**AMENDED  
RECORD OF DECISION  
OPERABLE UNIT 1**

**AMERICAN CREOSOTE WORKS SITE**

**Pensacola, Escambia County, Florida**

**U.S. Environmental Protection Agency**

Figure 5. Typical Cross Section of Low-Profile Surface Cap

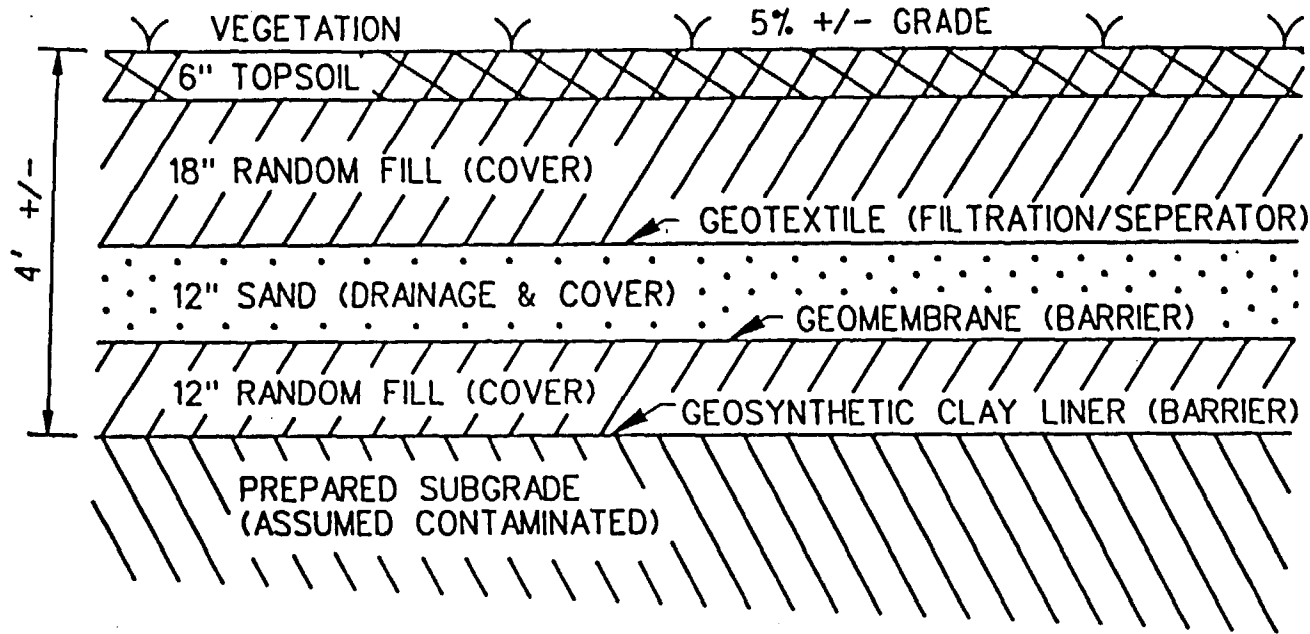
**Comment:** A commenter asked about the details of cap construction, including specifics about the barrier cloth, lines, and depth of clay. How will the cap be maintained, and what will be done to prevent roots from disrupting the cap? The commenter felt that a slurry wall or perimeter barrier must be constructed to prevent superficial ground water from flowing through highly contaminated areas of the Site.

**Response:** Cap construction details are presented in Section 10.1 of this AROD, and a cross-section showing the layers of the cap is provided in Figure 5. As part of the operation and maintenance (O&M) plan for the Site, the cap and the entire ACW property will be mowed as necessary during the growing season, which should prevent the growth of deep rooted plants. However, periodic inspections of the cap will be conducted following construction to evaluate the condition of the cap and drainage features, and a maintenance program will be implemented to prevent growth of trees or other deep-rooted vegetation from penetrating the barriers and to fill in any erosion that may occur. Future use of the Site will be limited to uses that do not require significant ground penetrations. Holes for poles, borings, trenches and other excavations deeper than 6 inches will not
